**Public Hearing for an Amendment to the
Planned Unit Development (PUD) – Lot
14A and 15A Southport East Replat Eight
and Lots 1-4 Southport East Replat Nine –
The Lund Company**

RECOMMENDATION REPORT

CASE NUMBER: PPUD-17-0004

RE: Proposed Securities American Expansion & Offsite Parking Lot Facility
Amendments to PUD Plans-Ordinances 1020 and 1045

Exhibit B

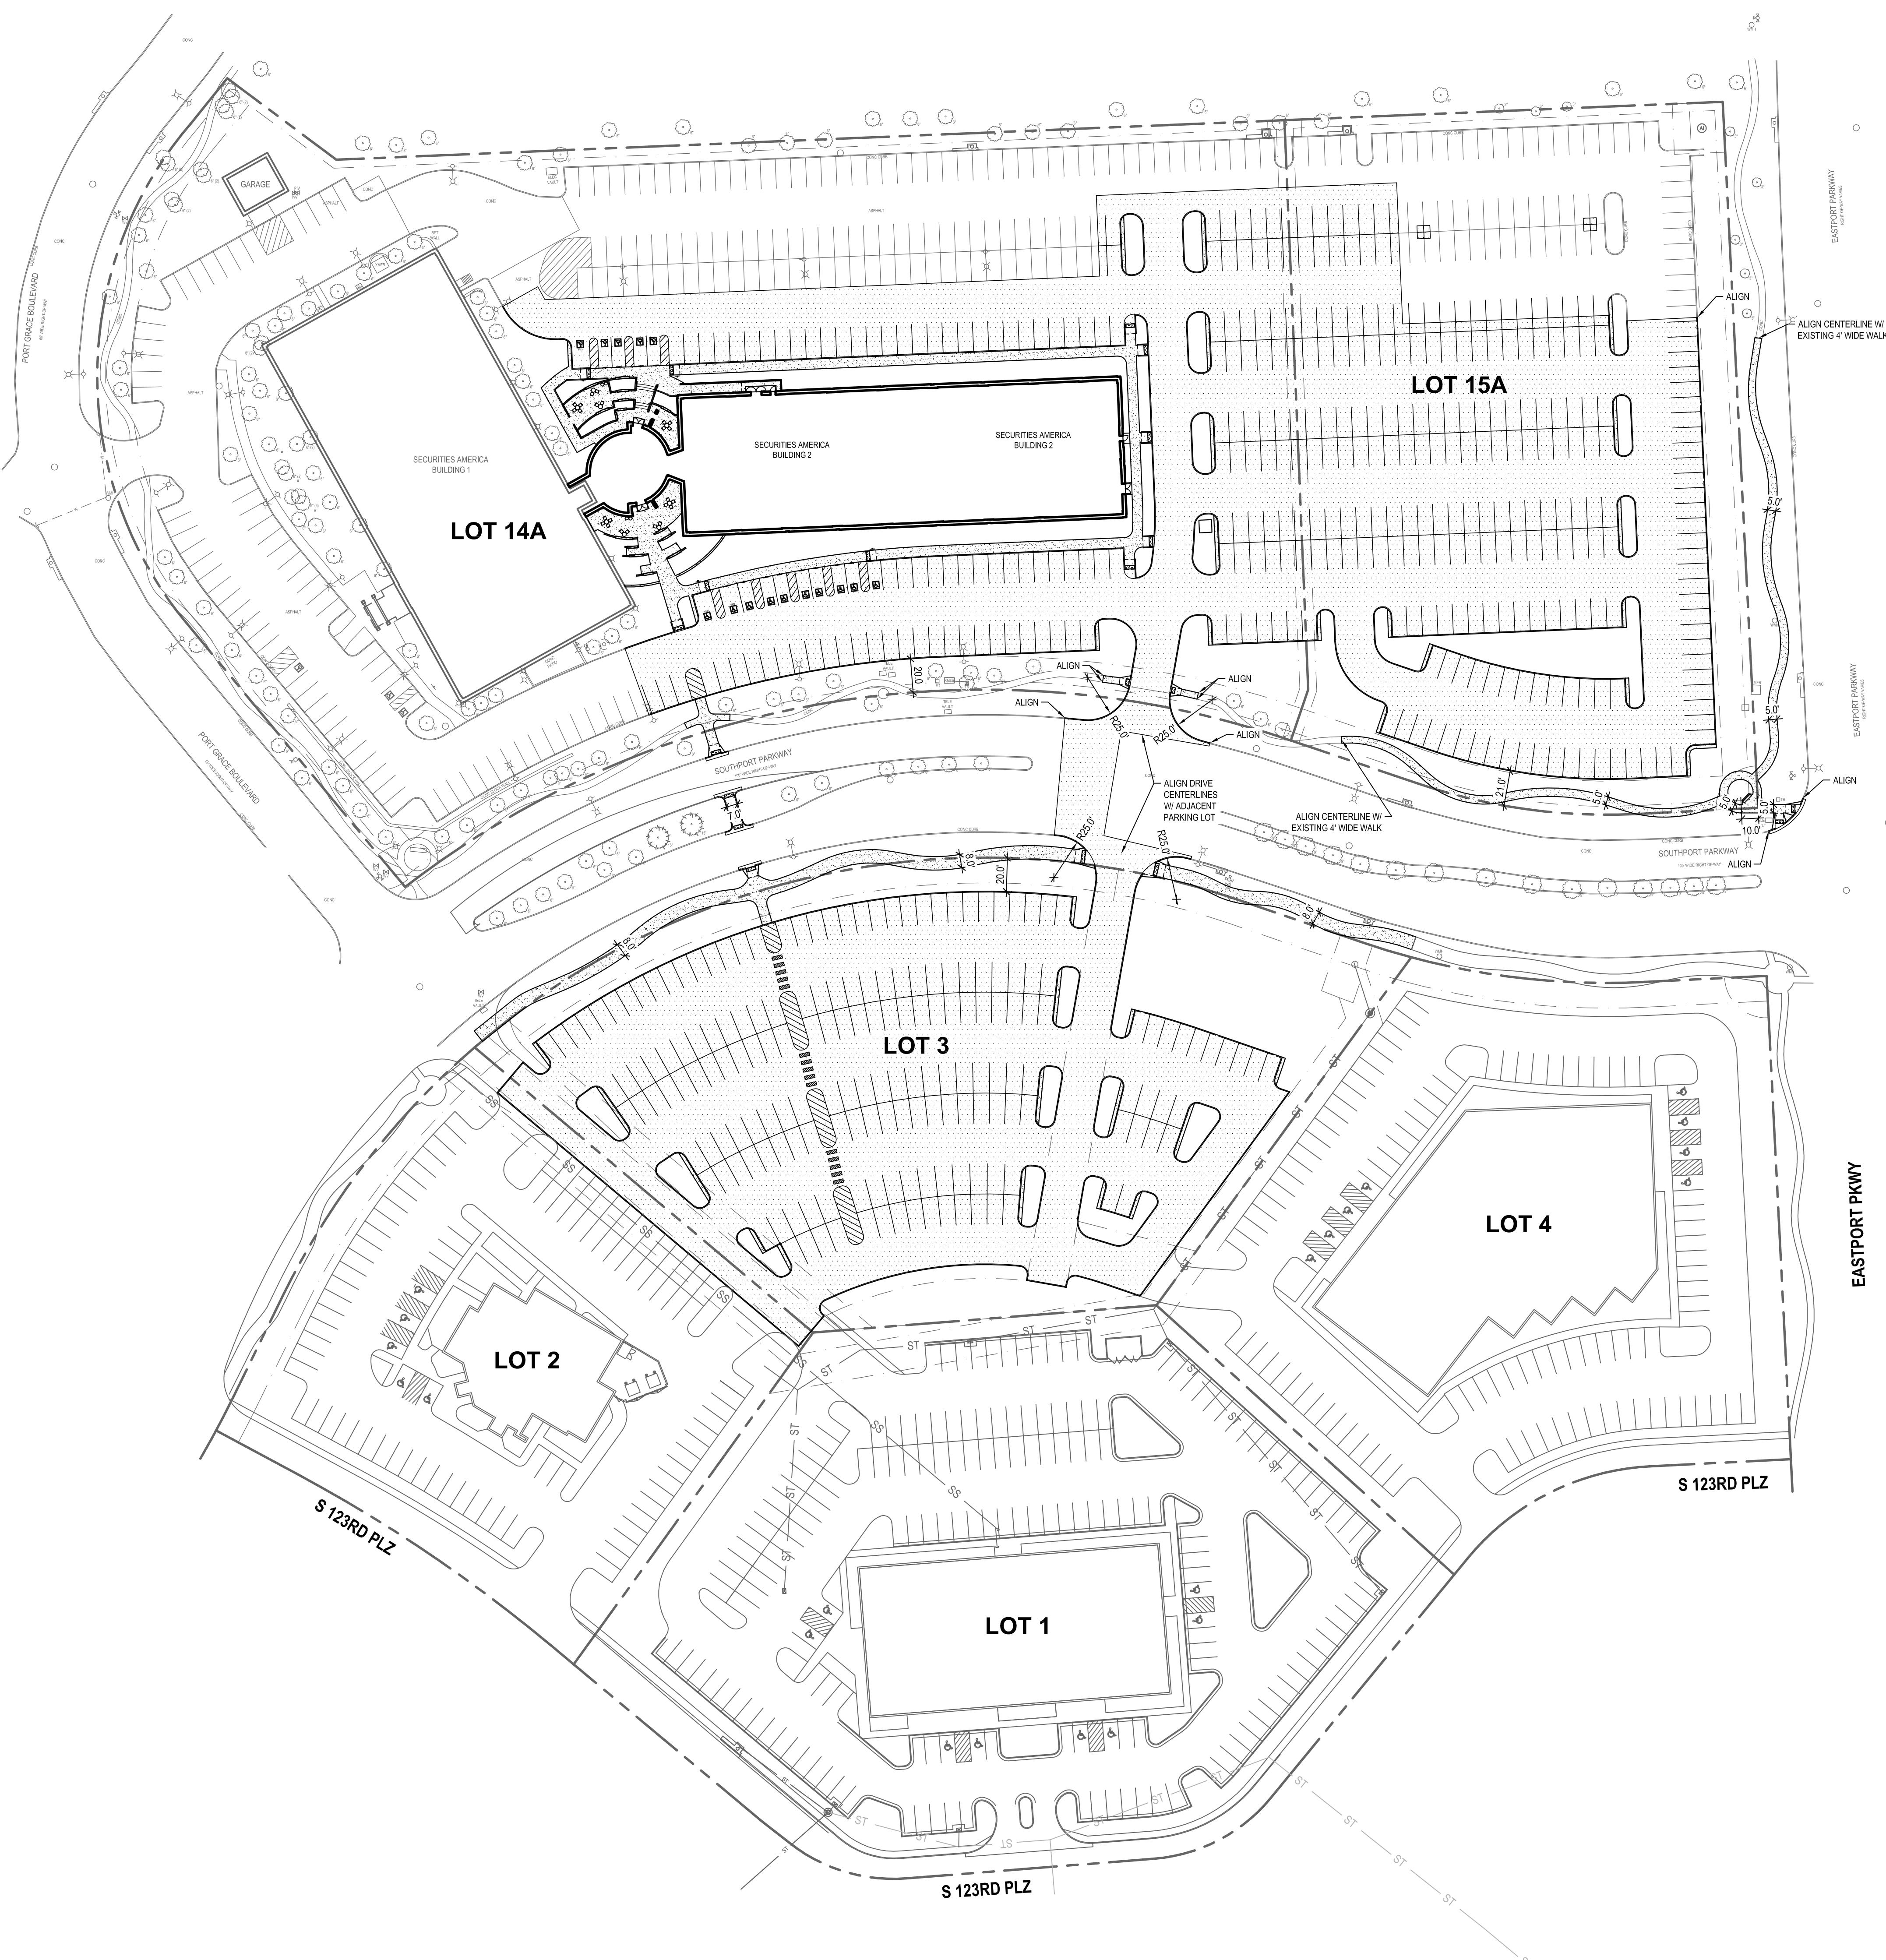
8. Articles 5.15.04.08 & .09: The Southport East Design Guidelines requires a 20 foot wide landscaped area along Southport Parkway. However, the landscaped area along Southport Parkway on north side of Lot 3 is depicted as 15 feet. Additionally, Ordinance 1045 requires 25% greenspace on Lot 3. Although it would appear that this requirement is met, the data needs to be provided on the plan.

See Site Paving Plan - Exhibit B.

Exhibit D1

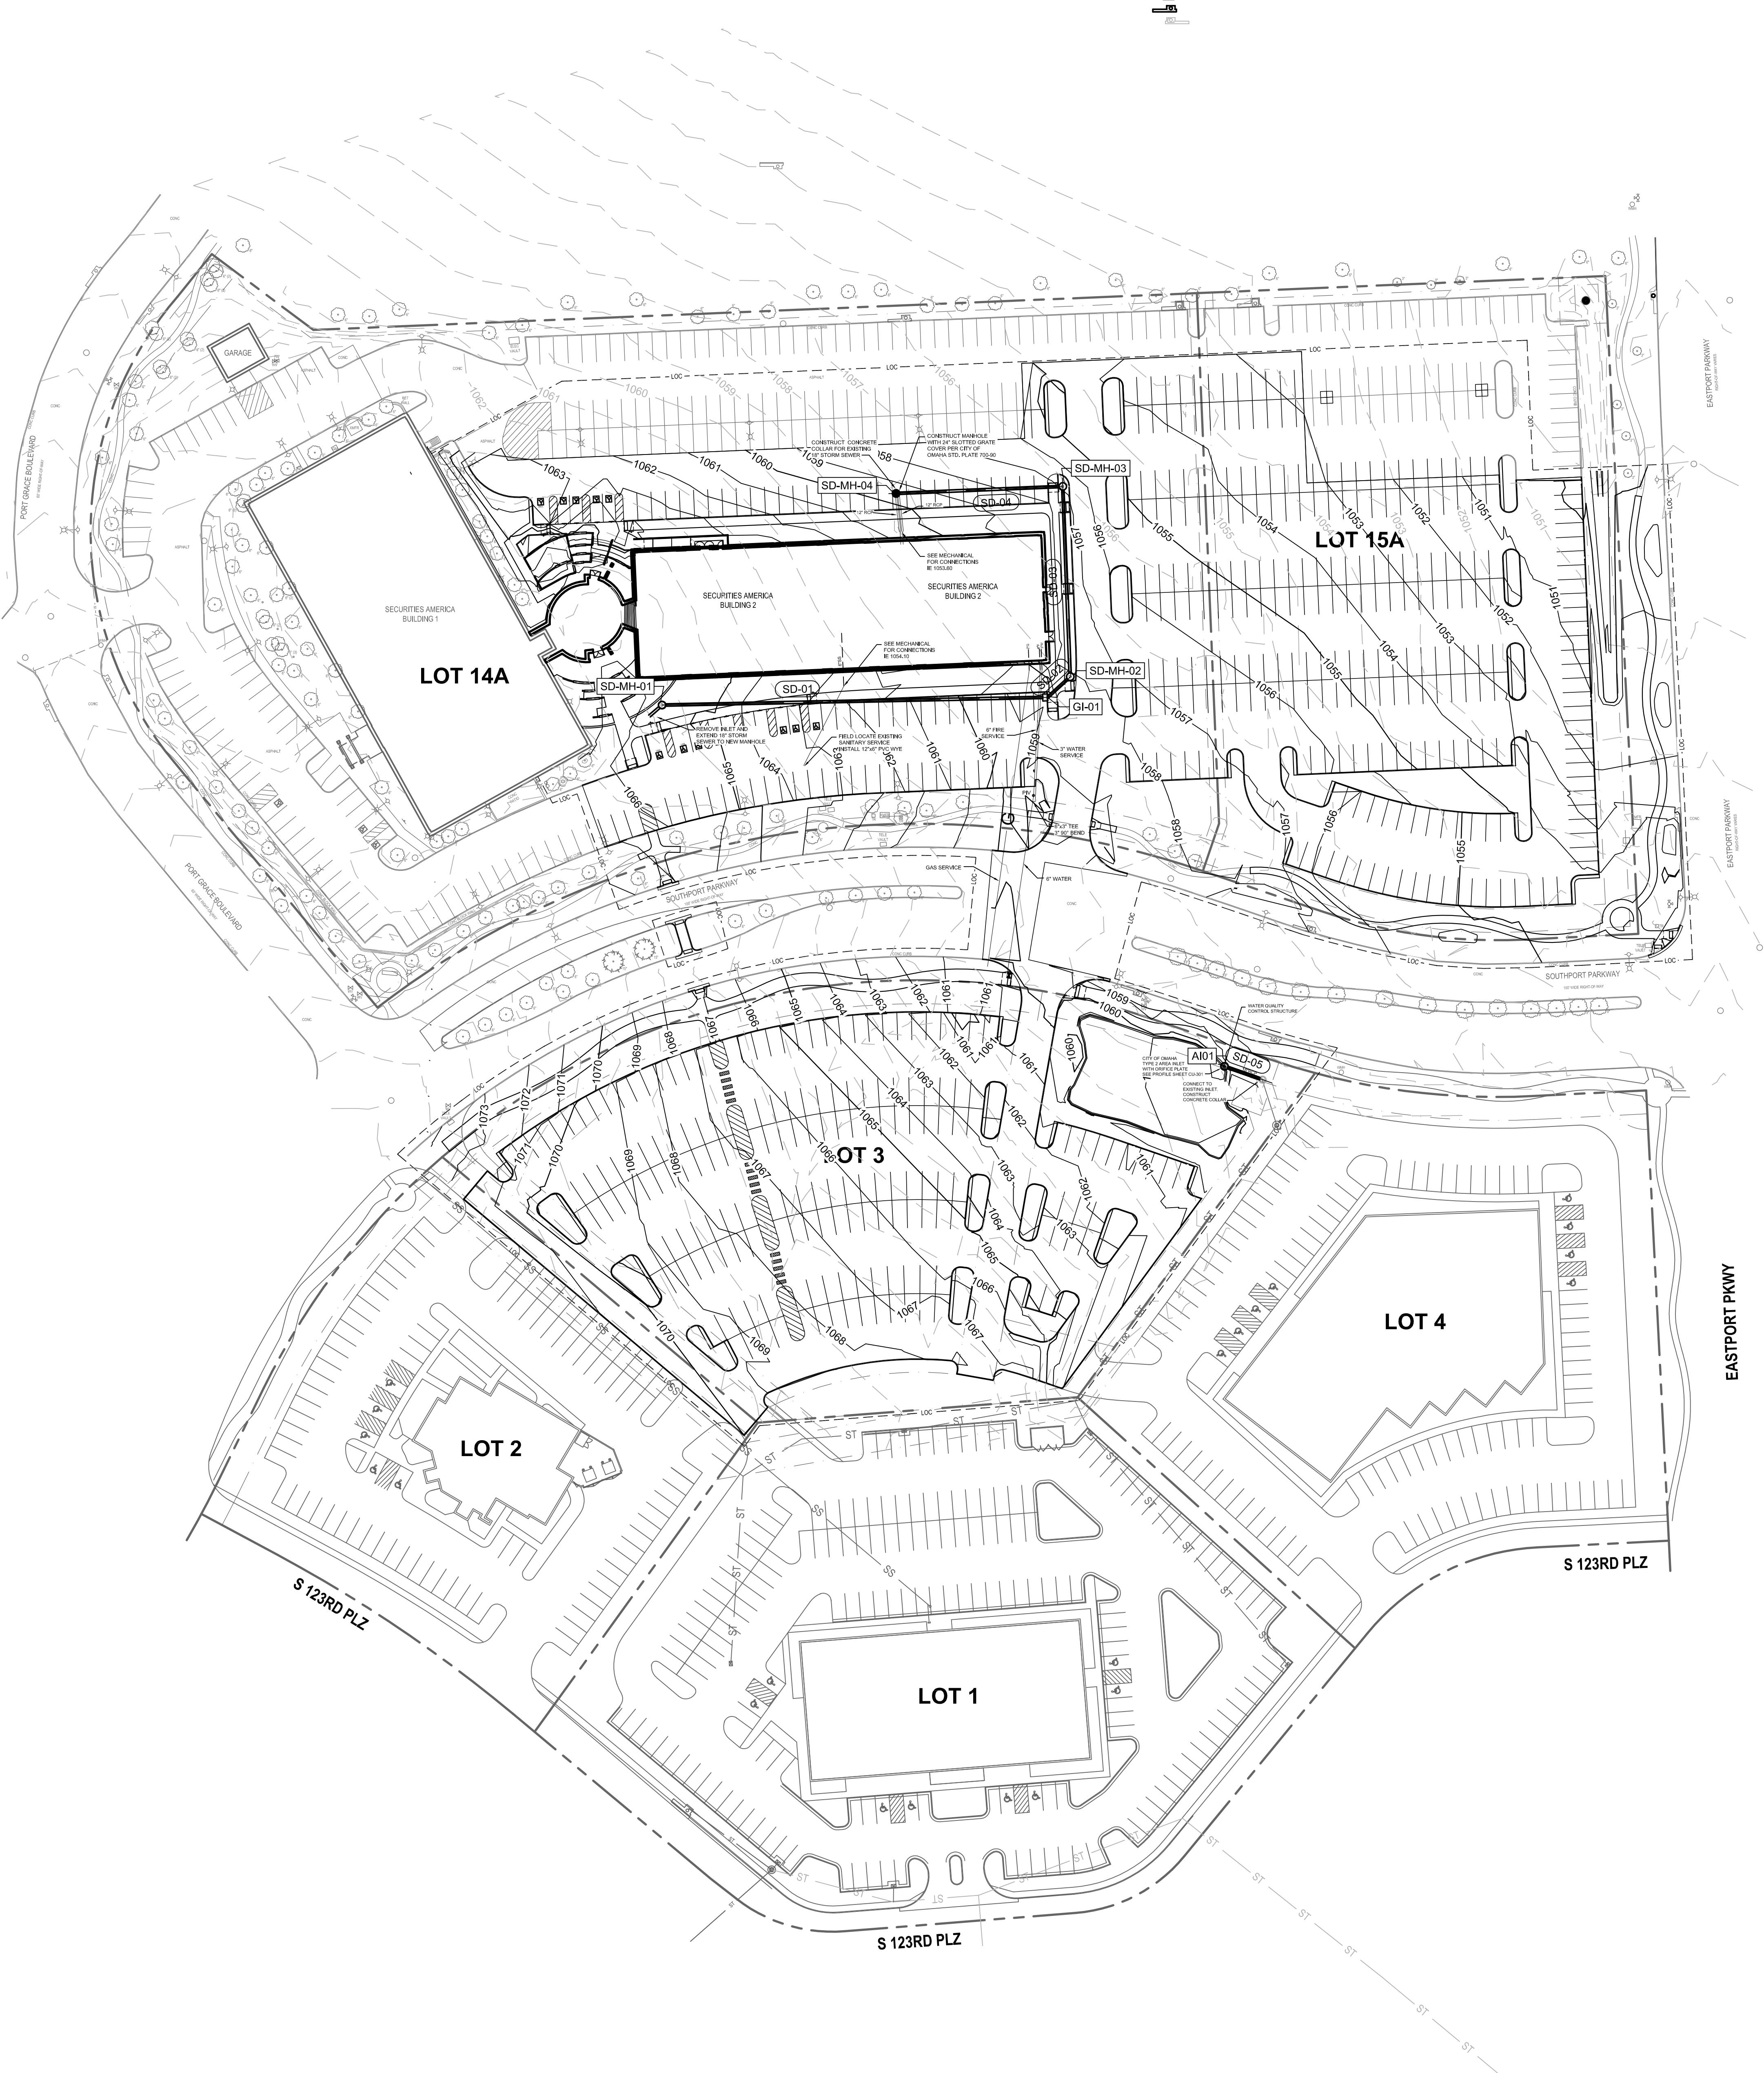
18. Article 5.15.05.04: See Item 6a above. Also, revise Exhibit D1 to show the portion of Lot 14A and 15A that will need to receive water quality treatment for compliance with Chapter 154 of the La Vista Municipal Code for new impervious surface and significant redevelopment. With this letter is an exhibit of what portion the City Engineer interprets as coming under this requirement.
19. Article 5.15.05.05: No response was required.
20. Article 5.15.05.06: Exhibit "A" provided a satisfactory response to this comment.
